LIC-16-0076  
September 2, 2016

Fort Calhoun Station, Unit No. 1  
Renewed Facility Operating License No. DPR-40  
NRC Docket No. 50-285

Subject: License Amendment Request (LAR) 16-02: Revise the Fort Calhoun Station Emergency Plan to Address the Permanently Defueled Condition

Figure F-5 - Operations Liaison Network

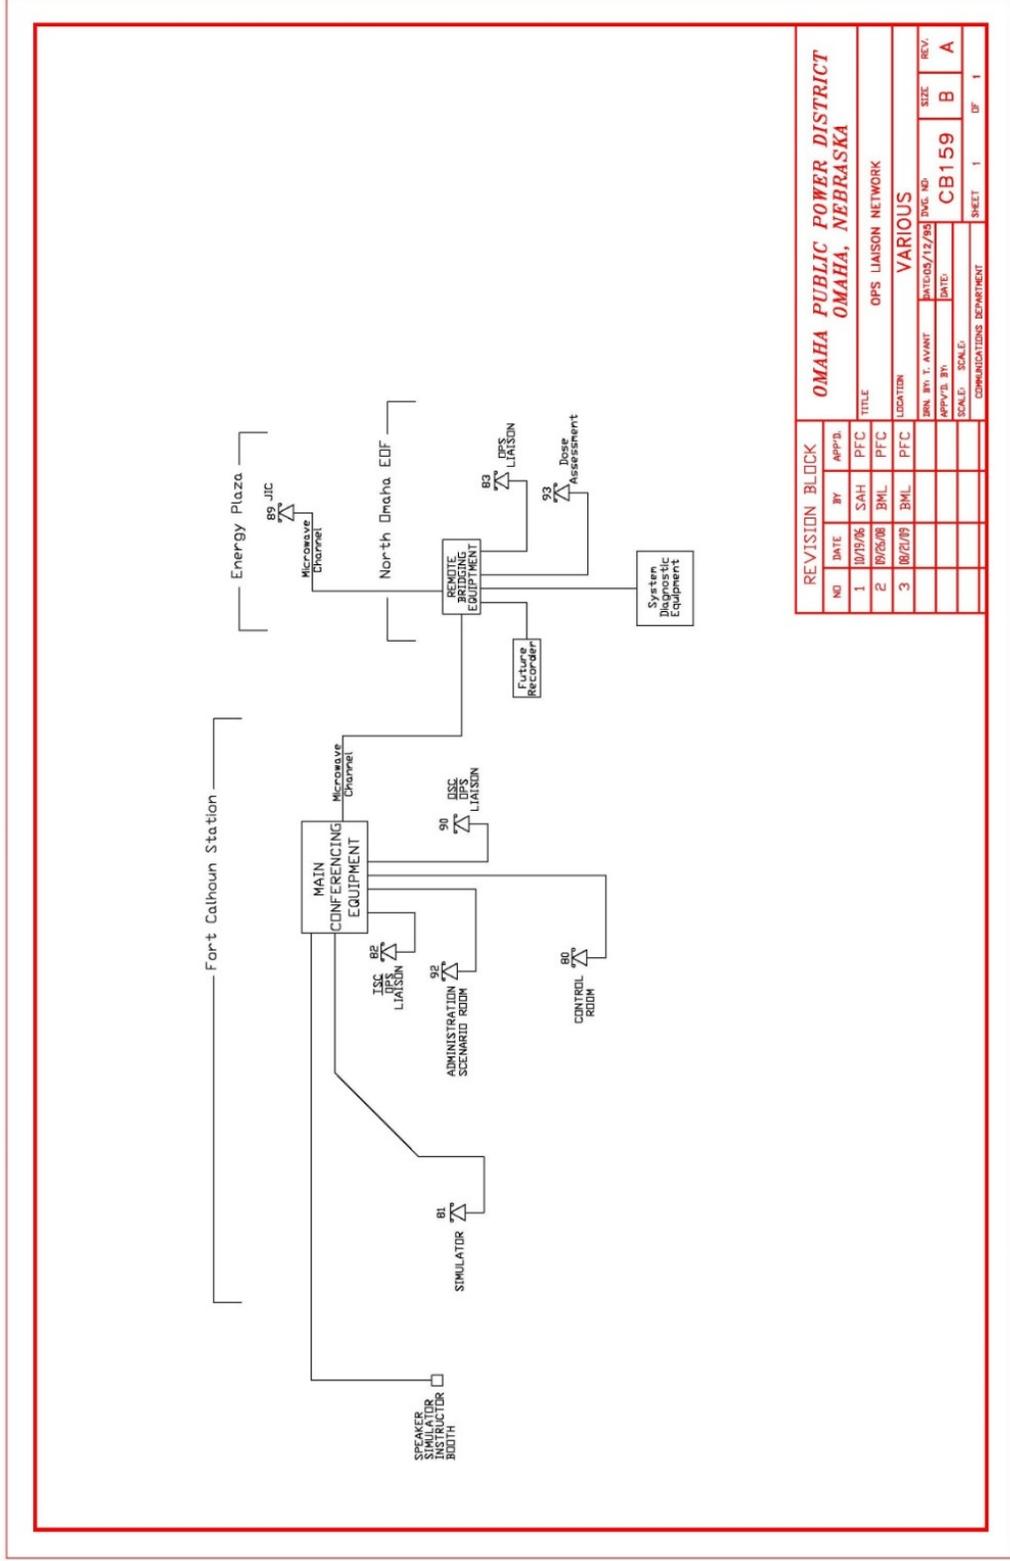
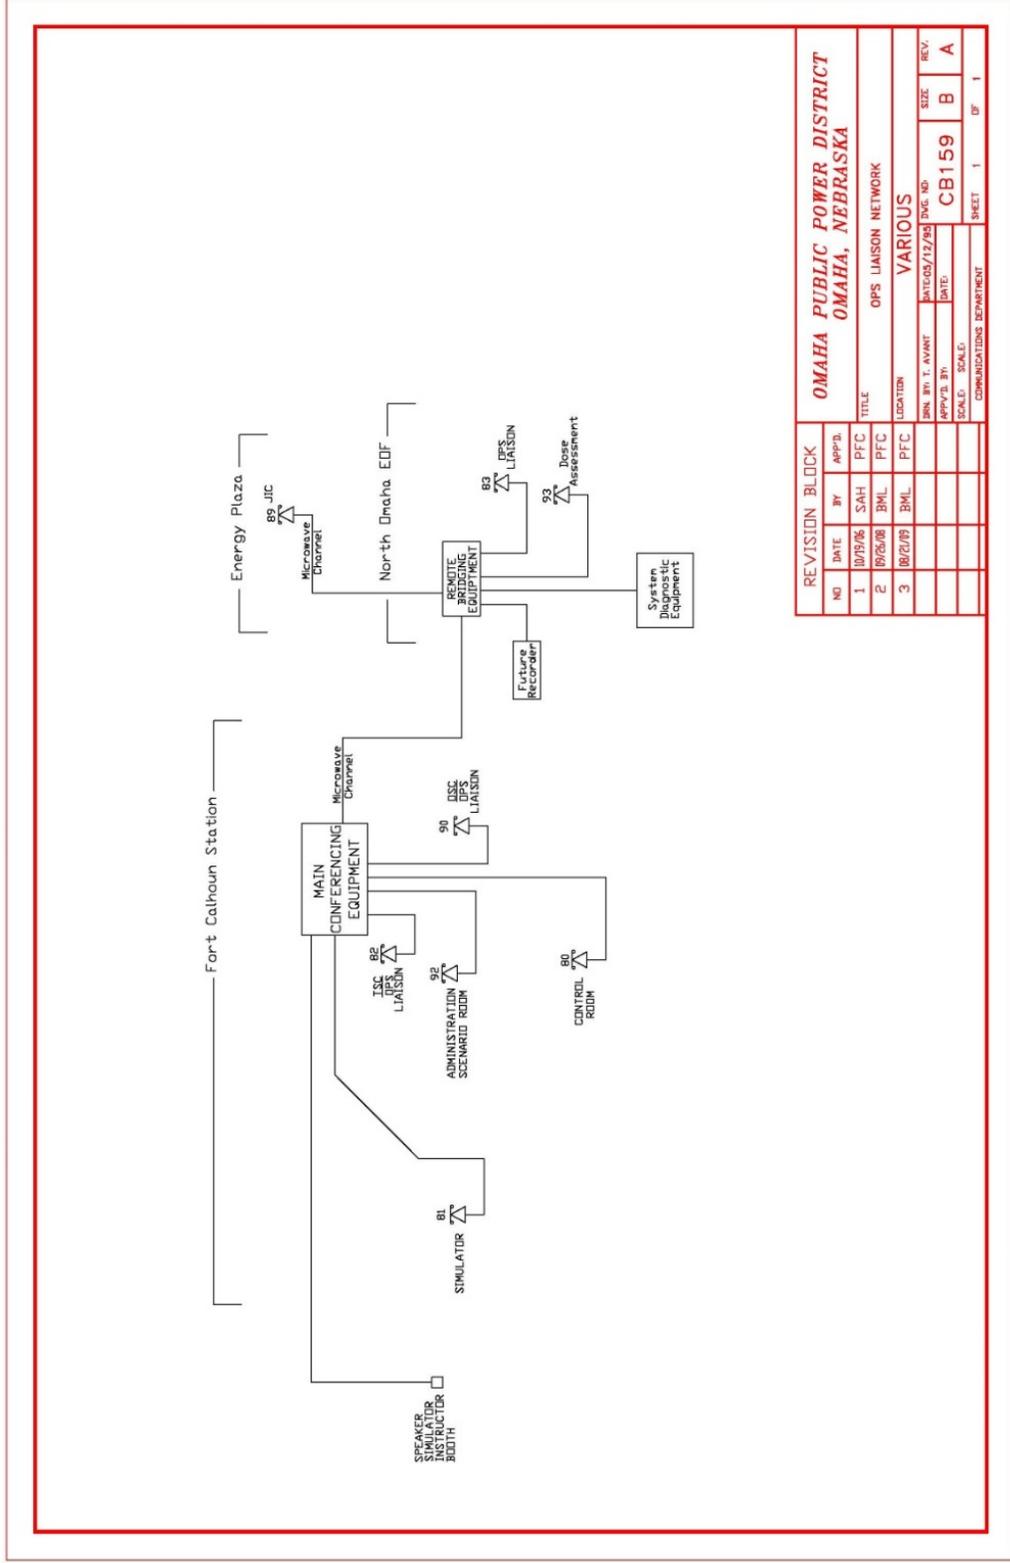
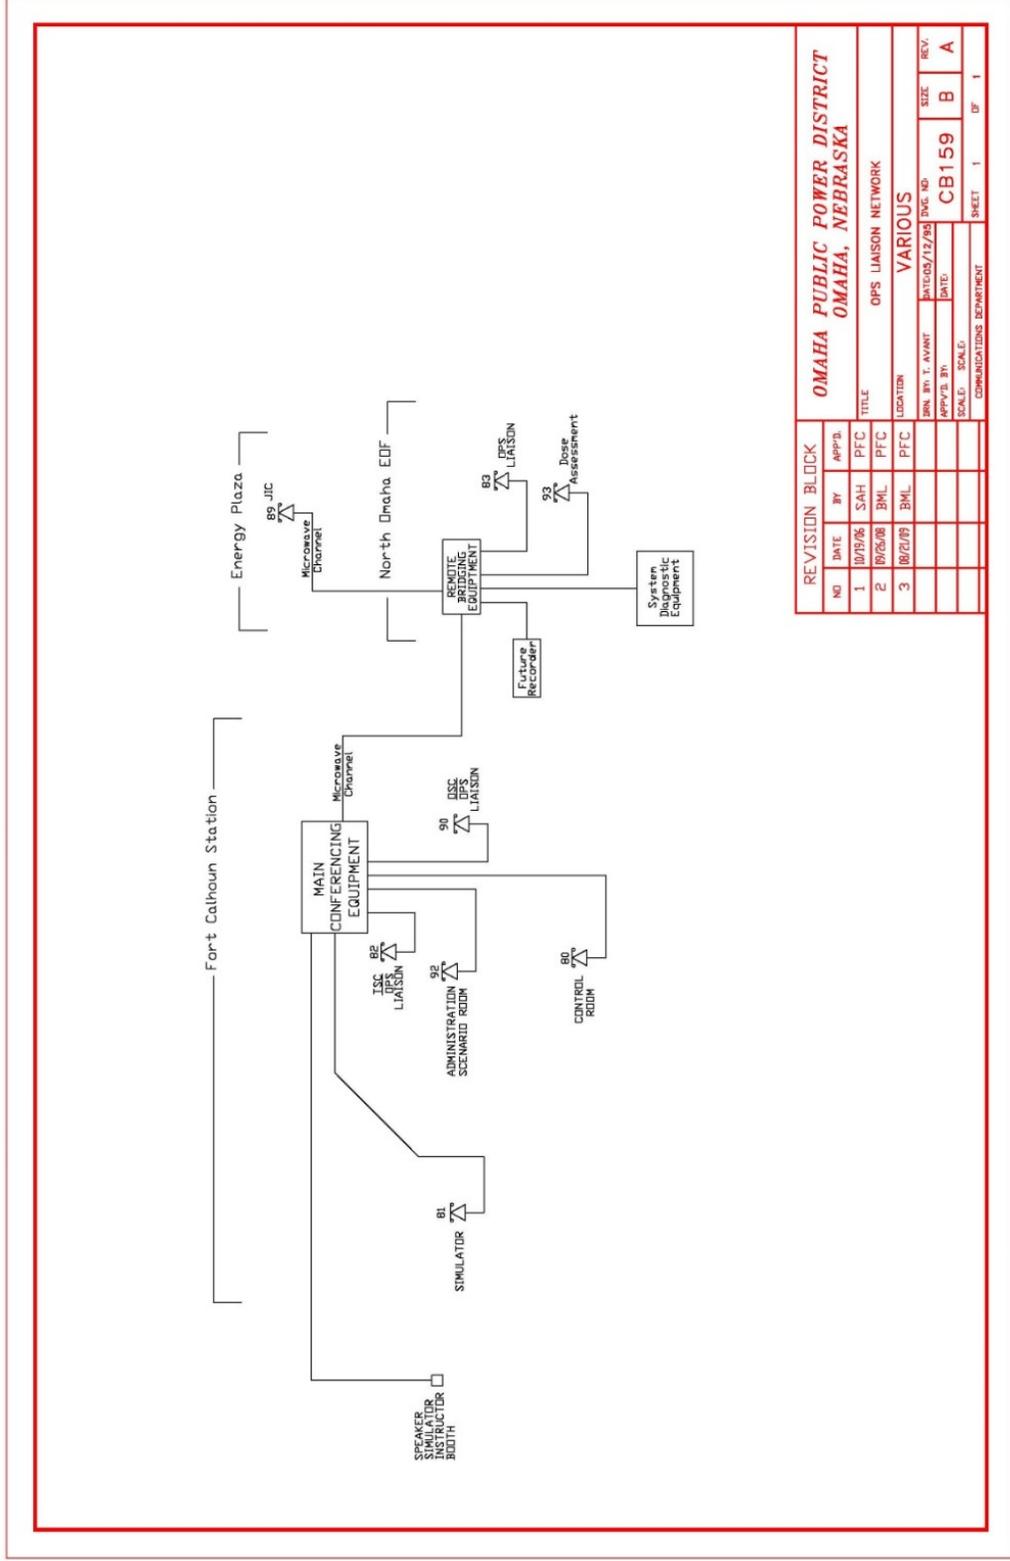
Section F, 2.17	joint Information Center Hot Line	Joint Information Center Hot Line	Editorial change.
Section F, 2.19.1	WEBeOC	WebEOC	Editorial change.
Section F, Figure F-5, Heading	Figure F-5 - Operations Liaison Network	Figure F-5 - Operations Liaison Network	Editorial change. Corrected spelling of "Liaison."
Section H (Corrected to "G", 2.1, 3 <sup>rd</sup> paragraph	The Joint Information Center also serves as the public inquiry center for OPPD, State and Federal authorities. The Public Inquiry Supervisor will serve as OPPD's representative in this area.	The Joint Information Center also serves as the public inquiry center for OPPD, State and Federal authorities.	The Public Inquiry Supervisor position will not exist in the post-shutdown ERO, as previously described.
Section H (Corrected to "G"), 3.0, , 5 <sup>th</sup> sentence	An JIC Technical Liaison at the Joint Information Center will assist in nuclear related information matters.	A JIC Technical Liaison at the Joint Information Center will assist in nuclear related information matters.	Editorial change.

Figure H-2 - Typical Technical Support Center Layout

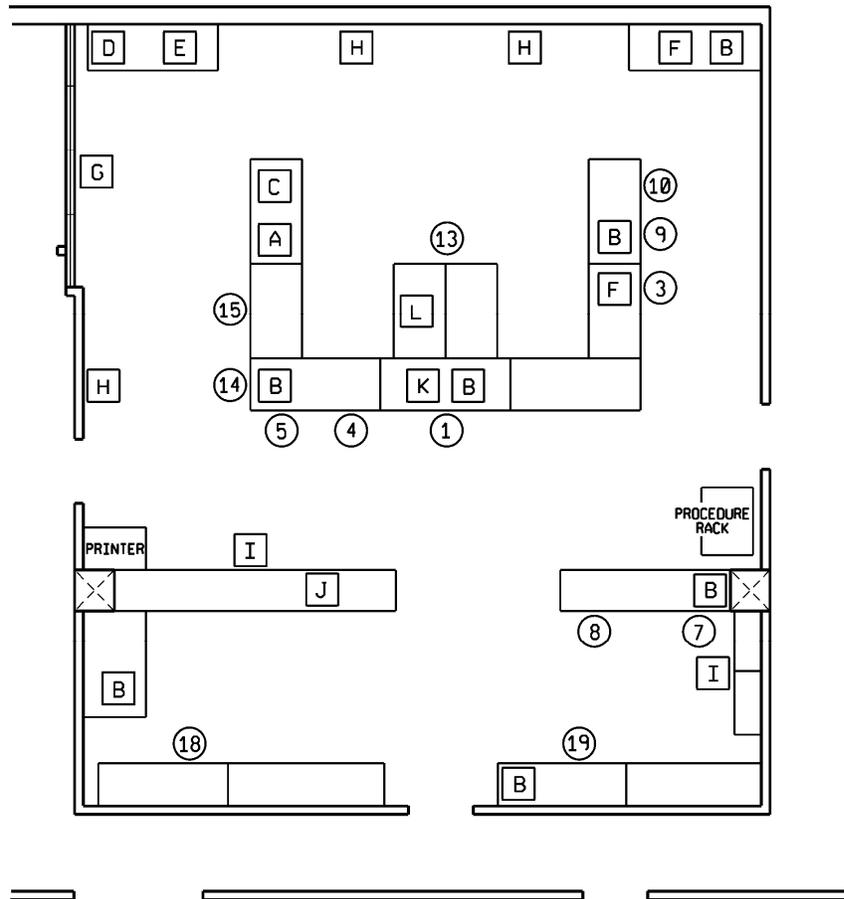
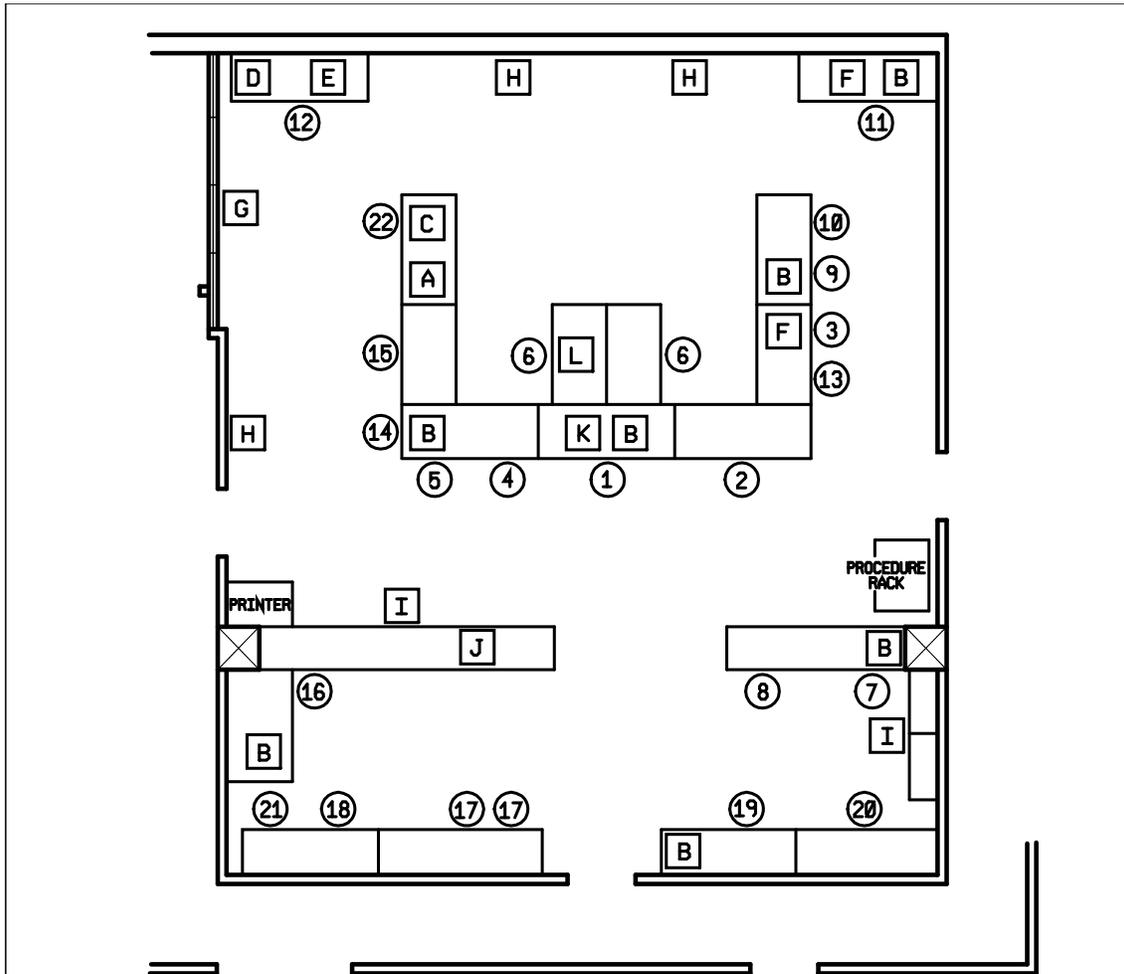
Emergency Plan Section	Before (Rev. 1)	After (Pending Revision Number)	Reason for Change
Section H, Figure H-2	2 – TSC DIRECTOR 6 – SITE DIRECTOR SECRETARY 11 – TSC STATUS BOARD KEEPER 12 – COP COMMUNICATOR 16 – ELECTRICAL/I&C ENGINEER 17 – PRIMARY SYSTEMS ENGINEER 20 – REACTOR ENGINEER 21 – SECONDARY SYSTEMS ENGINEER 22 – CHP COMMUNICATOR	Updated Figure to remove positions.	Positions will not exist in the post-shutdown ERO as previously described.
Section H, Figure H-2	7 – REACTOR SAFETY COORDINATOR	7 – ENGINEERING COORDINATOR	Position title changed, as previously described.
Section H, Figure H-3	1 – TSC ACCOUNTABILITY CLERK	Updated Figure to remove position.	The TSC Accountability Clerk position will not exist in the post-shutdown ERO. The proposed elimination of the TSC Accountability Clerk position has been evaluated in the FCS analysis of proposed post-shutdown ERO staffing.

Figure H-4 - Typical Operations Support Center Layout

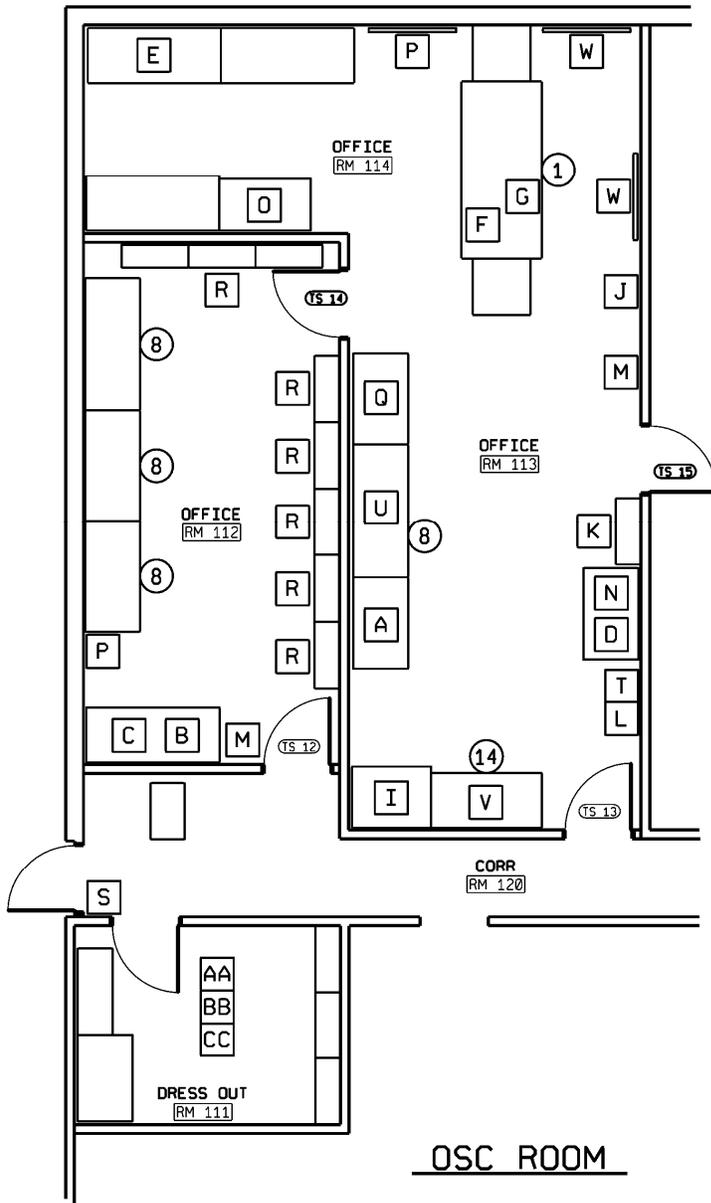
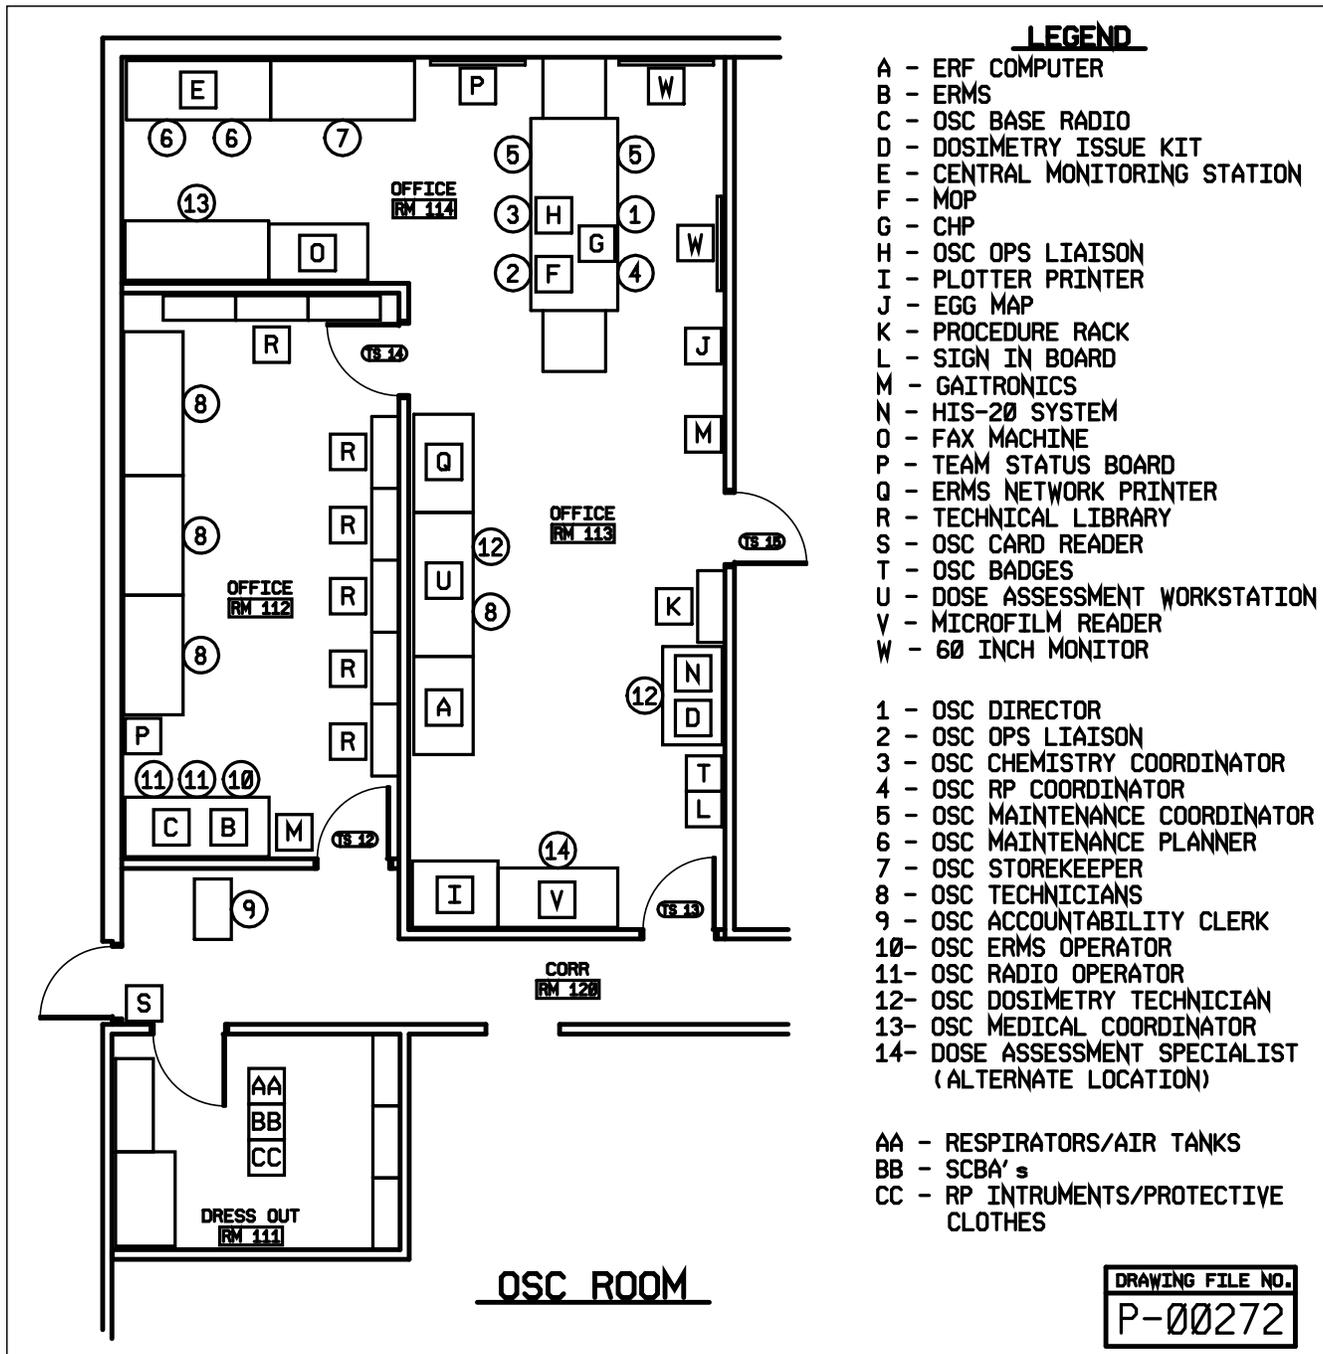
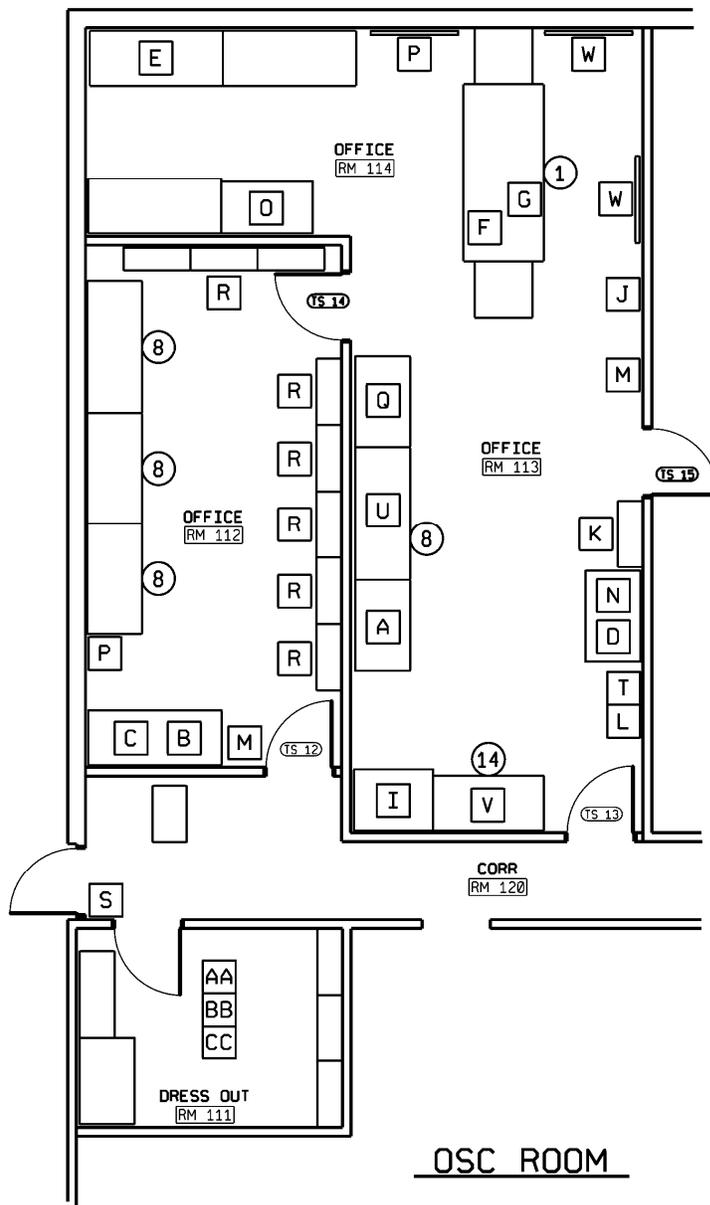
<b>Emergency Plan Section</b>	<b>Before (Rev. 1)</b>	<b>After (Pending Revision Number)</b>	<b>Reason for Change</b>
Section H, Figure H-4	3 – OSC CHEMISTRY COORDINATOR 4 – OSC RP COORDINATOR 5 – OSC MAINTENANCE COORDINATOR 6 – OSC MAINTENANCE PLANNER 7 – OSC STOREKEEPER 9 – OSC ACCOUNTABILITY CLERK 10 – OSC ERMS OPERATOR 11 – OSC RADIO OPERATOR 12 – OSC DOSIMETRY TECHNICIAN 13 – OSC MEDICAL COORDINATOR	Updated Figure to remove positions.	Positions will not exist in the post-shutdown ERO, as previously described.
Section H, Figure H-5	2. Emergency Director Secretary/ERMS 6. EOF Dose Assessment Coordinator 9. EOF Dose Assessment Assistant 14. EOF Secretary 15. EOF Clerical Assistant 16. EOF Status Board Keeper 17. EOF Communications Specialist 19. EOF Information Technology Specialist 20. EOF Emergency Response Coordinator 21. CHP Communicator	Updated figure to remove positions.	Positions will not exist in the post-shutdown ERO as previously described.
